### **SH16 Brigham Creek to Kumeu Stage 2 - Notice of Requirement Section 92 Response**

The following sets out our response to Auckland Council's RMA Section 92 request (dated 23/01/2023), in relation to the Notice of Requirement to Alter Designations 6740 and 6766 for State Highway 16 (Stage 2) Brigham Creek to Kumeu Safety, Capacity and Walking and Cycling Improvements, on behalf of Waka Kotahi New Zealand Transport Agency ("Waka Kotahi").

Figure 1: Latest Average Daily Traffic Counts from Auckland Transport dated 22 March 2021.

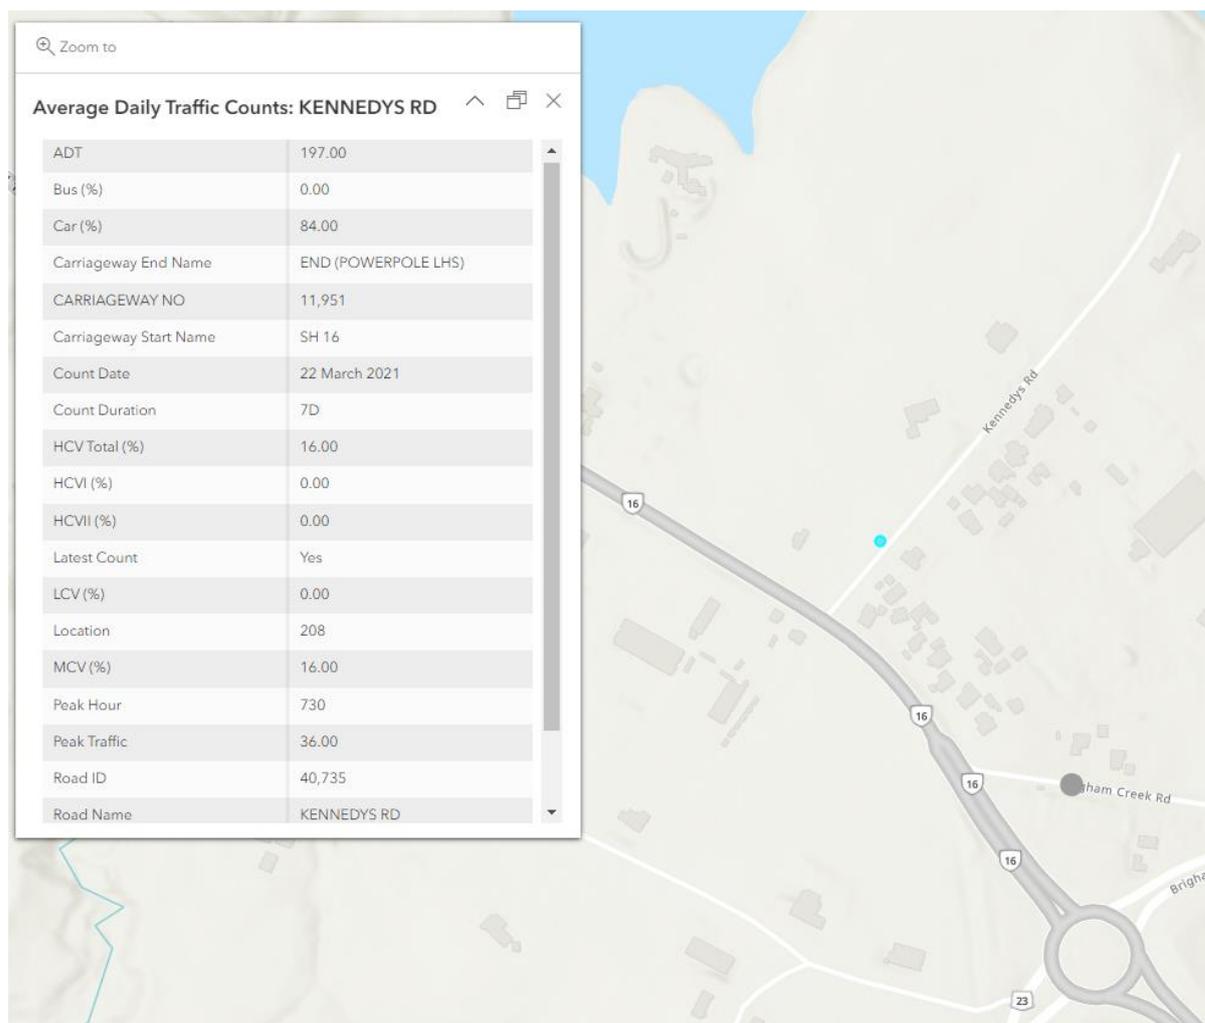
**Please provide details of the forecast traffic volumes along links and turning movements at key intersections (including Kennedy Road).**

Kennedy Road has not been specifically included in the traffic modelling given the low traffic volumes currently recorded. Latest Average Daily Traffic Counts from Auckland Transport dated 22 March 2021 are shown in Figure 1.

Figure 1: Proposed pedestrian crossing west of Brigham Creek Road roundabout

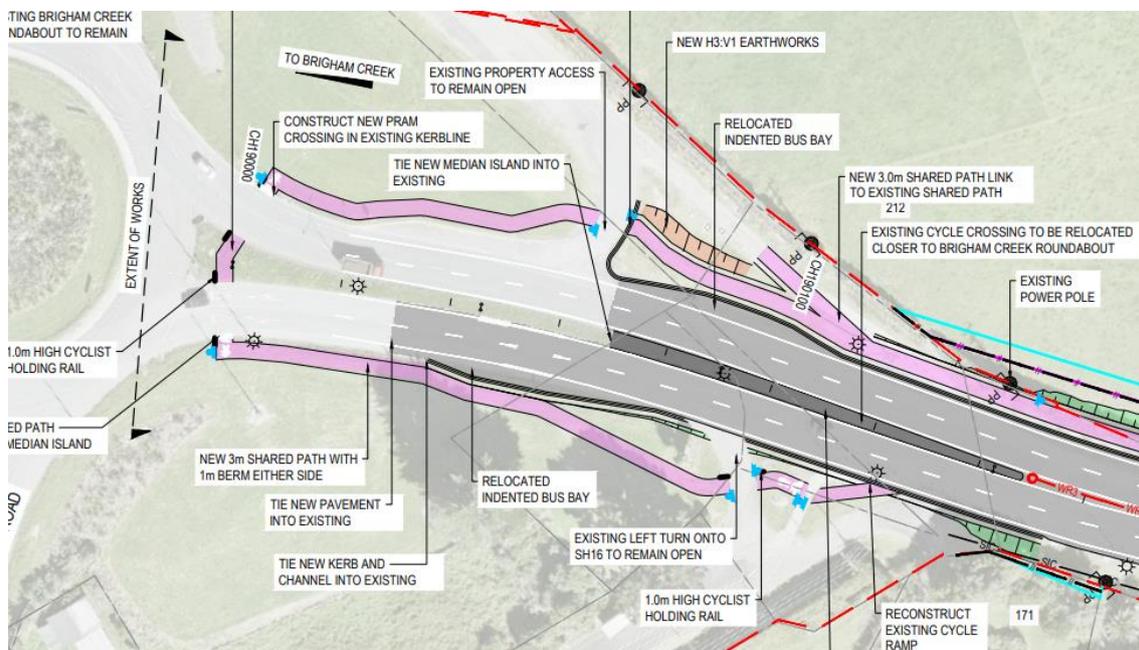
There is also the safety concern that the layout shown does not align with any desire lines, and that pedestrians and cyclists will try to cross at the current position, which would be even more unsafe due to even higher speeds and the unexpectedness of a crossing. It should be noted that the current crossing requires pedestrians and cyclists to cross only one lane at a time. It should also be noted that the fences in the current Brigham median refuge have been hit by a vehicle.

The proposed crossing shown in Figure 1 contrasts with the philosophy of raised and signalised pedestrian and cyclist crossing facilities applied at the proposed Coatesville-Riverhead Road roundabout, which should be considered for the Brigham Creek Road roundabout as well.

Figure 4: Example of safety barriers between kerb and shared path

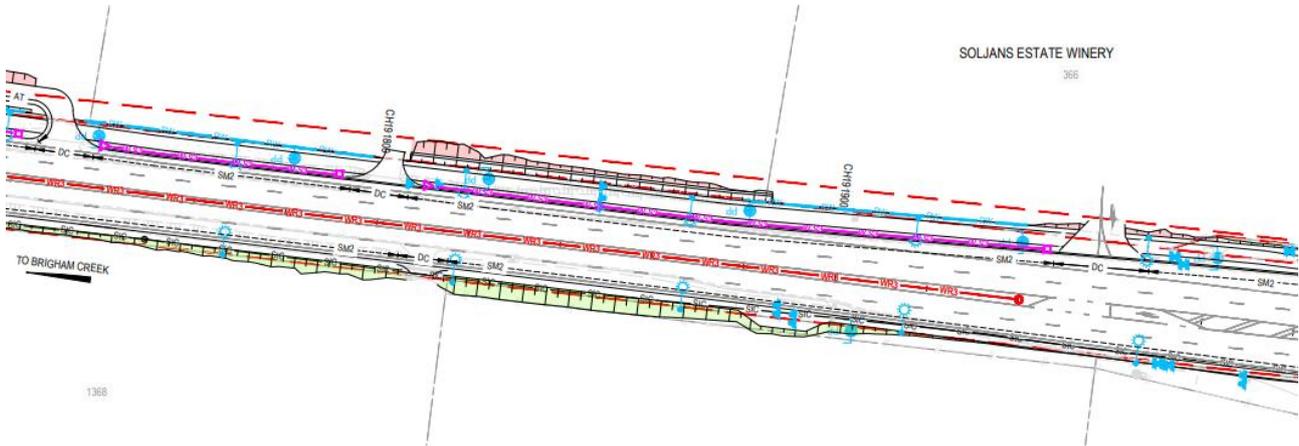
Semi-rigid barriers are proposed between the road and the shared path from Ch 192 500 to Ch 193 000 as shown in Figure 4. The reason for placing them in such a position is not clear as most if not all existing power poles are shown to be removed and the services relocated underground. All lighting columns appear to be frangible and ground planted, which would not require barriers, and are shown 0.4 m clear of the back edge of the path.

Figure 7: Bus stop cross-sectional detail

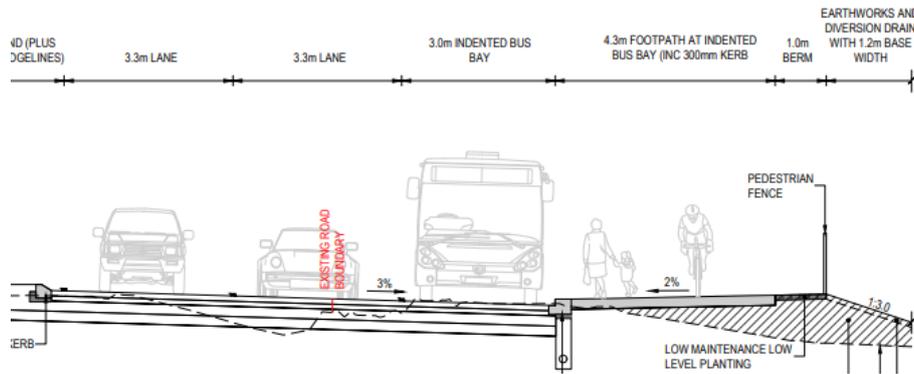
There are bus stops proposed adjacent to the shared path. The typical cross-section of one of the bus stops shows a 4 m wide path behind a 0.3 m Kassel kerb. The safety concern is that the path would not be wide enough for a bus stop, shared path, and bus shelter, and that there would be no clear demarcation of pedestrian or passenger priority over cyclists. There have been recent crashes with death and serious injury outcomes involving passengers alighting from buses at poorly designed or narrow bus stops.

The width of indented bus bays is shown in Figure 7 as 3.0 m adjacent to a 3.3 m wide lane. For the speed environment, the combined 6.3 m width might not provide enough separation between the bus and passing heavy vehicle traffic, particularly if the bus driver does not pull completely into the bus bay.

Figure 8: Cross-section at BP Service Station

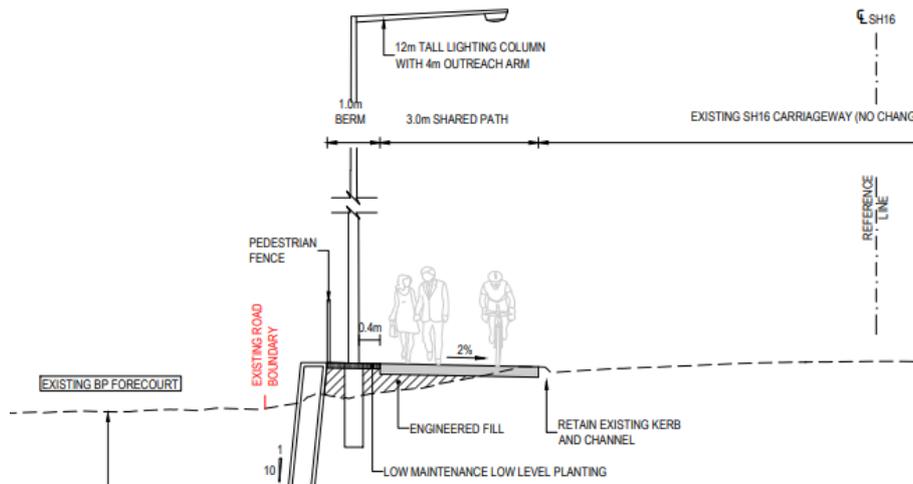
Cross-section 13 at the BP Service Station shows the shared path hard up against the kerb with no buffer strip, yet there is a 1.0 m berm between the back of the footpath and the low retaining wall in which there is only one lighting column.

On site, it did not appear that the retaining wall would be required if the footpath sloped at 2 % towards the garage forecourt, thus lowering the back of path by 160 mm as has been proposed at the retaining wall shown in Figure 5. This would also match the entry and exit levels closely and avoid the back of path sloping longitudinally up and down at each crossing.

Figure 9: Proposed termination location of two-westbound lanes

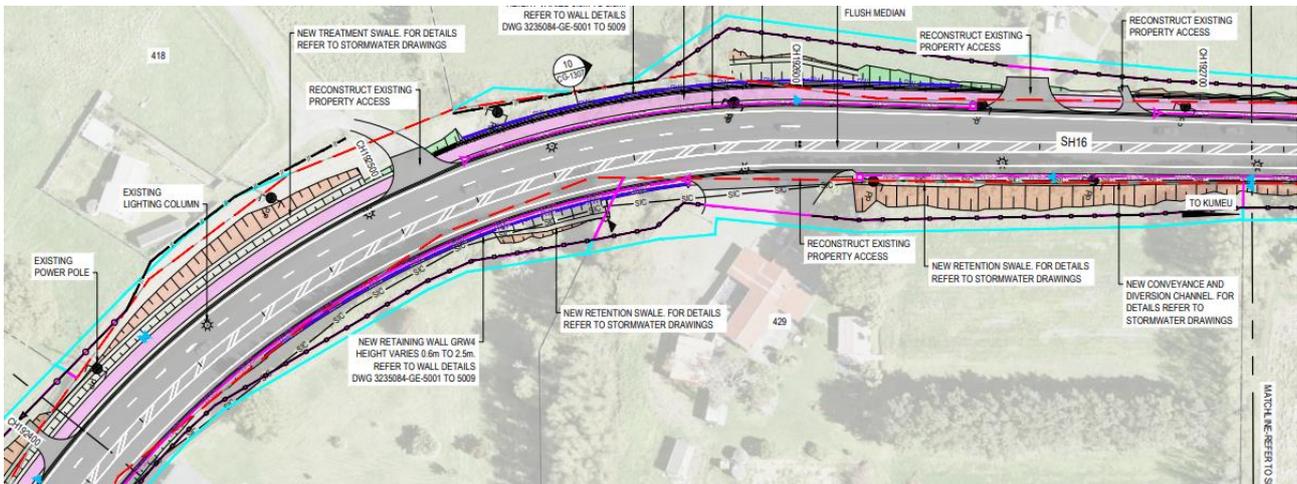
In a previous audit, the safety auditors recommended shifting the merge of the two westbound lanes from its present position about 150 m downstream of the Taupaki Road roundabout to a position about 450 m downstream of the roundabout and past the right-hand curve. The current proposed design incorporates this recommendation as shown in Figure 9.

Figure 10: Coatesville-Riverhead Road roundabout circulating lane markings

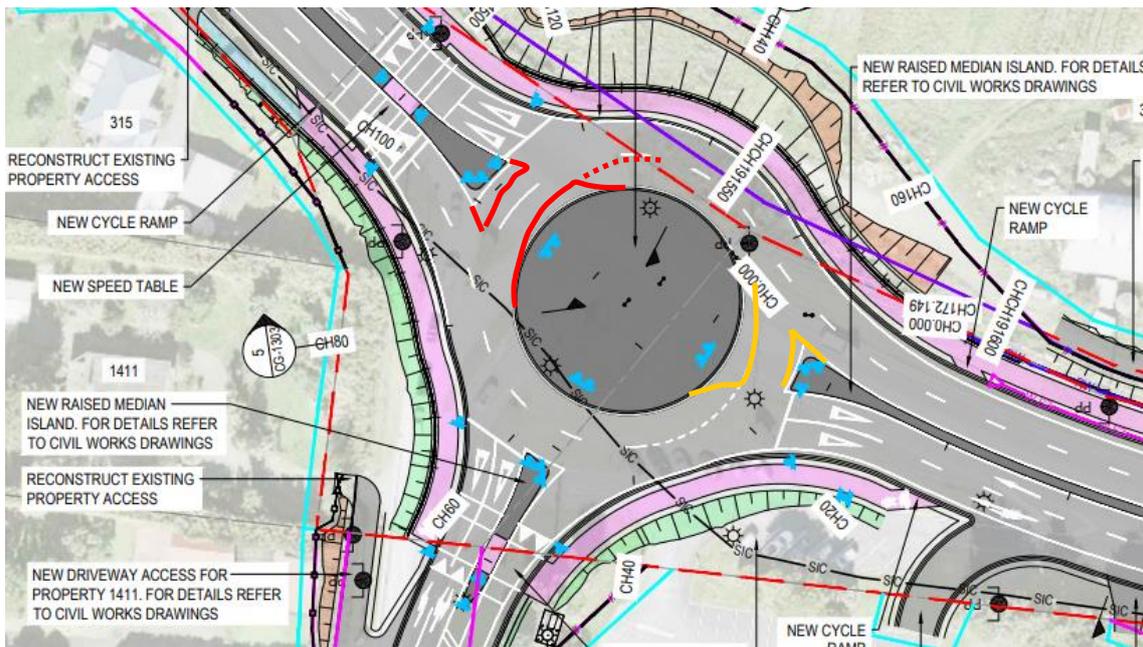
The spirally marked right turn from SH16 into Coatesville-Riverhead Road has a dead area as shown in gold in Figure 10 and should either be kerbed or hatched out. This is important for drivers making U-turns who need to be directed into the outside lane, especially if their access is a short distance from the roundabout and there is little opportunity to change lanes downstream of the roundabout. Such drivers could become trapped in the inside lane.

The proposed spiral marking outlined in gold also creates a less acute angle of intersection than desirable, which could increase the severity of injury of a crash. The red outline on the opposite side of the roundabout illustrates how the angle can be improved by developing the spiral later. Note the dead area in red is half the size of the dead area in gold.

Figure 15: Kennedys Road left-in and left-out island

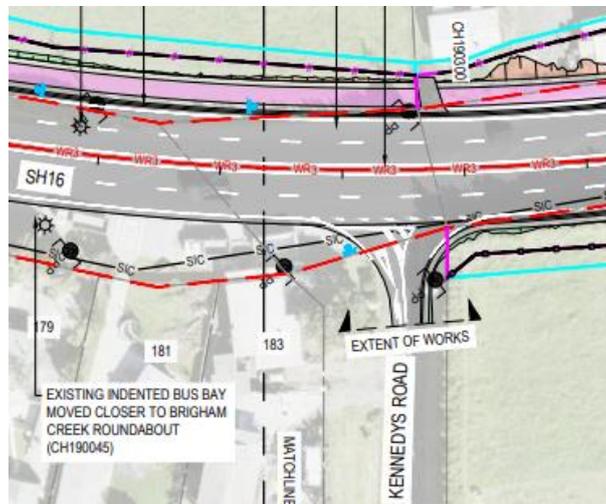
To avoid wrong way turns against oncoming traffic, those accesses that are generally used by the public should have a raised triangular median to reinforce the obligatory left-turn. The drawings do show a painted island at Kennedys Road, but it could become invisible on a wet night.

Figure 16: Example of proposed excessively wide access

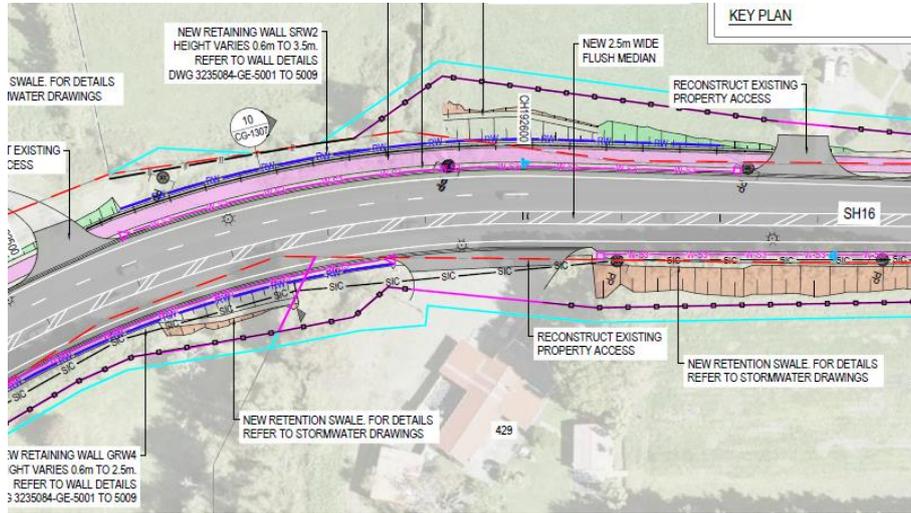
Some of the accesses are shown very wide. Examples are at Ch 191 200, at Ch 192 600, at Phil Greig Strawberry Gardens, and at Ch 193 350. This could lead to high-speed exits endangering others in the car park or on the shared path for instance.

Figure 17: Soljans Estate Winery entrance

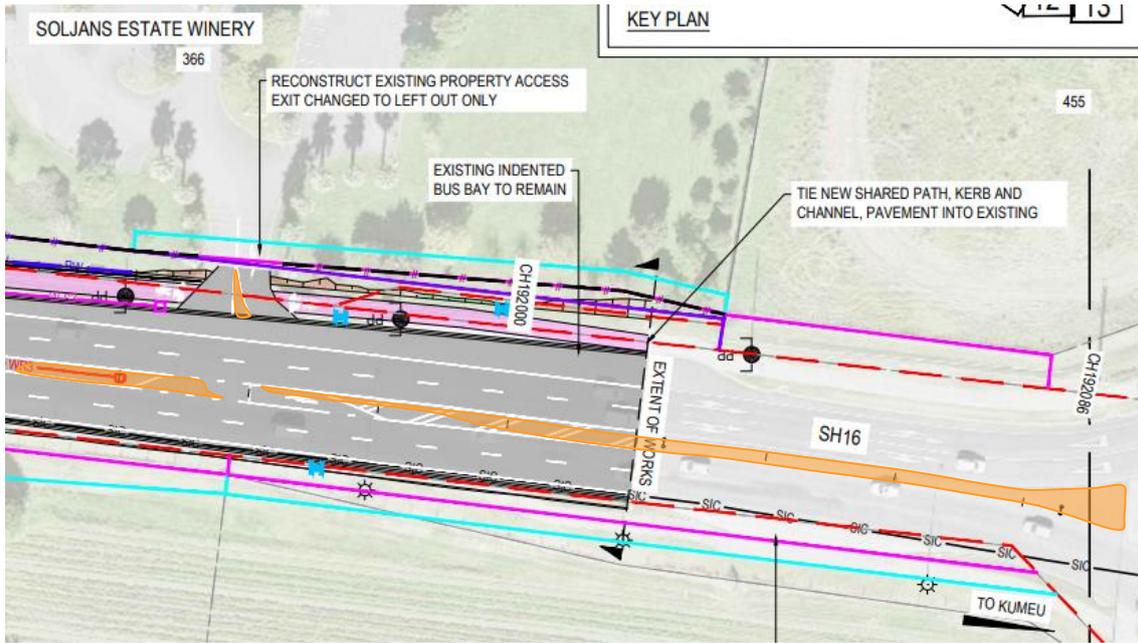
The Soljans Estate winery access arrangement shown in Figure 17 is intended to allow right turns into the winery but not right turns out of the winery and into SH16. It is unlikely that the the proposed layout would prevent such turns physically though.

It is noted that the Soljans Estate Winery acknowledges the unsafe nature of its access as is evidenced by the sign on its gatepost shown in Figure 2 recommending to those exiting the winery that they should make a U-turn at the Taupaki Road roundabout if wishing to proceed eastwards.

1. Preferably, prohibit right turns altogether by extending the median barrier up to the roundabout and by constructing a raised island to direct drivers to turn left when exiting the winery.
2. If the banning of right turns is prohibitive, then extend the existing raised median of the roundabout eastwards past the winery entrance and create a curved portion as suggested in Figure 17 to prevent right turns out of the winery. Consider what the safe and appropriate speed limit should be having allowed right turns into the winery.

Figure 18: Kumeu Produce market entrance

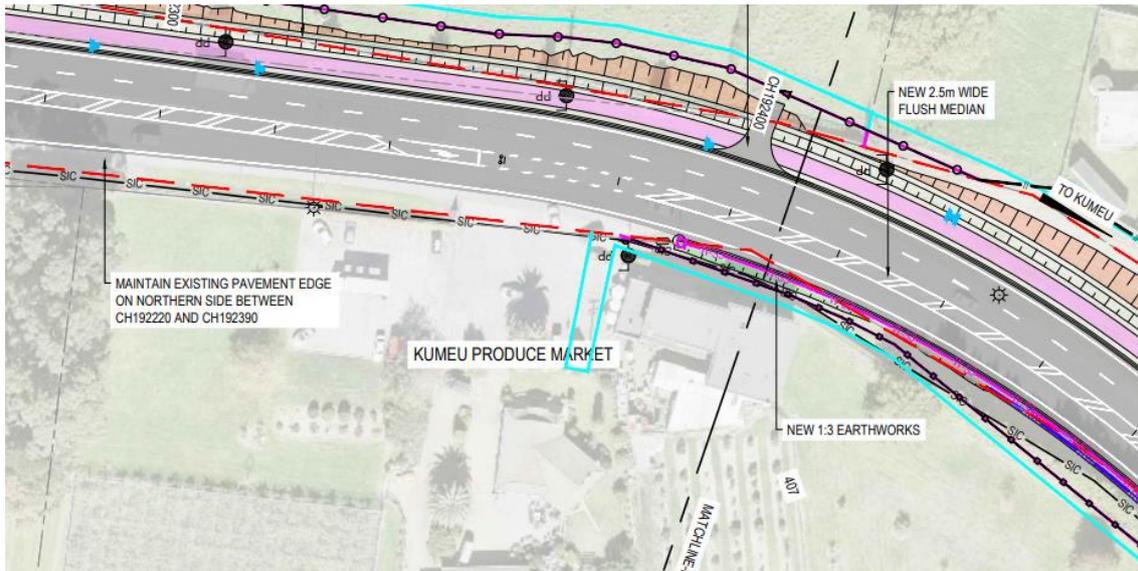
This lack of adequate sight distance highlights the need for the selection of a safe and appropriate speed limit. With a lower speed limit, the curve could perhaps be tightened slightly to provide even more sight distance.

Figure 19: Currently proposed Boric Supermarket access

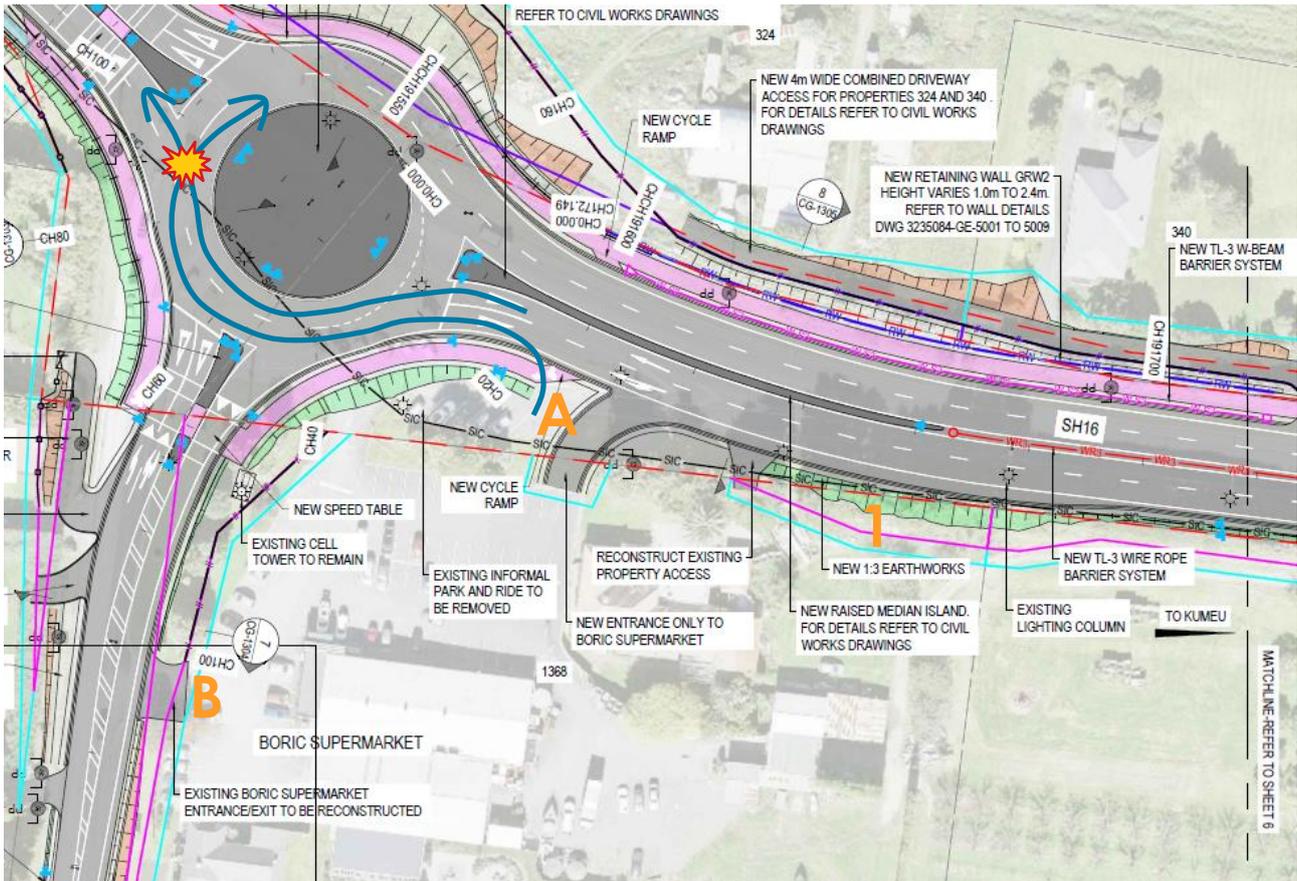
The left-in only proposal for access to the Boric Supermarket off SH16 eastbound carriageway shown at point A in Figure 19 was revised during the safety audit to fulfil a previous design phase undertaking to provide a left-in and left-out access to SH16 at the same point A location. This was further revised during the audit to shift the left-in and left-out access to the west at Point 1 in Figure 19. The road safety audit team understands that direct access to SH16 is an entrenched property right and that the access only from Coatesville-Riverhead Road at point B would not be an acceptable compromise.

For the record, the designed wide entrance only (left-in only) access shown at A in Figure 19 could have been mistaken for a two-way entrance leading to head-on crashes in the entrance and possible wrong way turns onto SH16. This is particularly the case if signs are faded or damaged or go missing. It would also have been on an adverse 7% crossfall for traffic turning left into the supermarket, which could have been problematic for heavy vehicle stability if taken too fast.

A two-way access at point A in Figure 19 would have been too close to the roundabout. This could have resulted in drivers turning left out of the supermarket into lane 1, due to the heavy traffic, and then trying to U-turn across straight through eastbound traffic passing through the roundabout and crashing at the point indicated.

1. Although the safest would be to direct all the Boric Supermarket traffic to the Coatesville-Riverhead Road access, a two-way access as a far west of point 1 in Figure 20 would be safer than any access closer to the roundabout.
2. Reduce the proposed 7 % superelevation at the new access to avoid heavy vehicle instability when turning into the access from SH16.

**Figure 12: Suggested improvements to Boric Supermarket access**

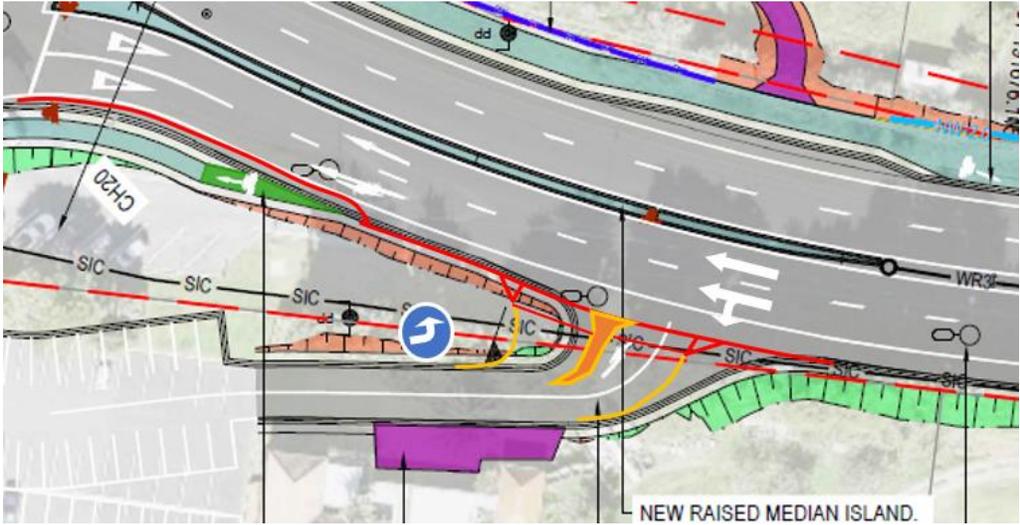
There is also a risk that the access will look like a replication of the existing left-turn slip lane, and that drivers will enter it at speed not realising that it ends in a car park, and that it is two-way.
